UNITED STATES PATENT AND TRADEMARK OFFICE

APPLICATION NO.	FILING DATE	FIRST NAMED INVENTOR	ATTORNEY DOCKET NO.	CONFIRMATION NO.
09/886,550	06/21/2001	Stephen L. Clark	4524B	8232

Office Action Summary

Attachment A

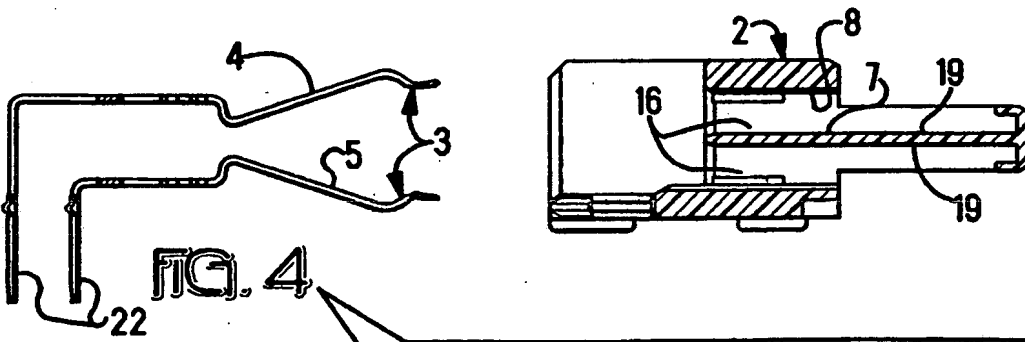
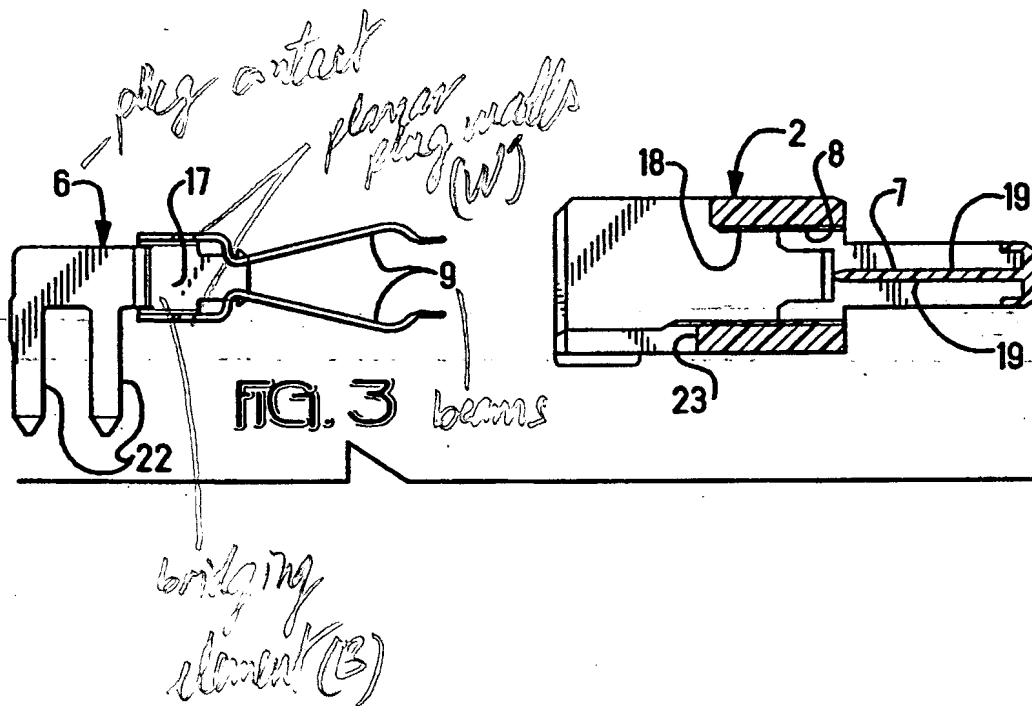
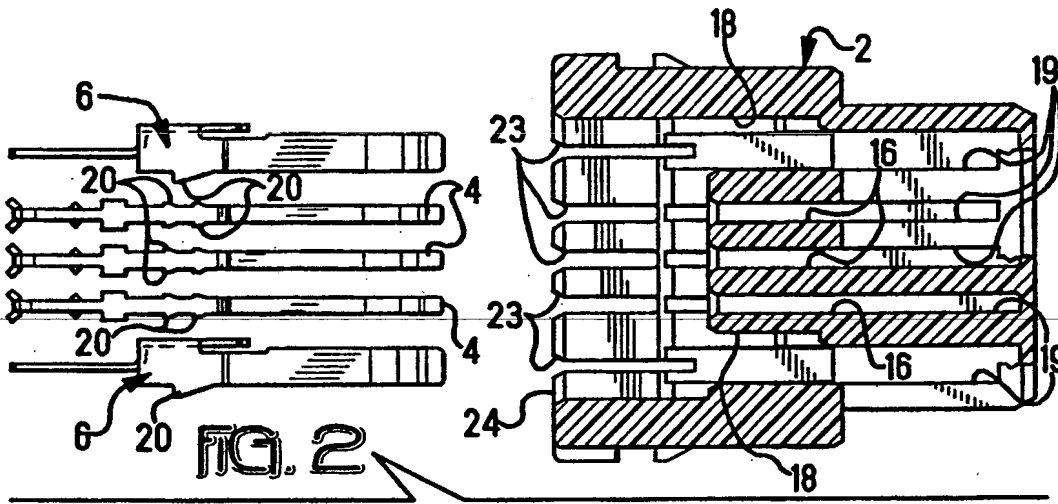
The disclosure of Davis shows each and every element set forth in these claims. For example: Figs. 3, 9, 11 and Attachment A show a power receptacle 6 with a pair of spaced apart planar walls (W), a power plug 6 having space apart planar walls (W'), each wall having a beam 9 extended therefrom.
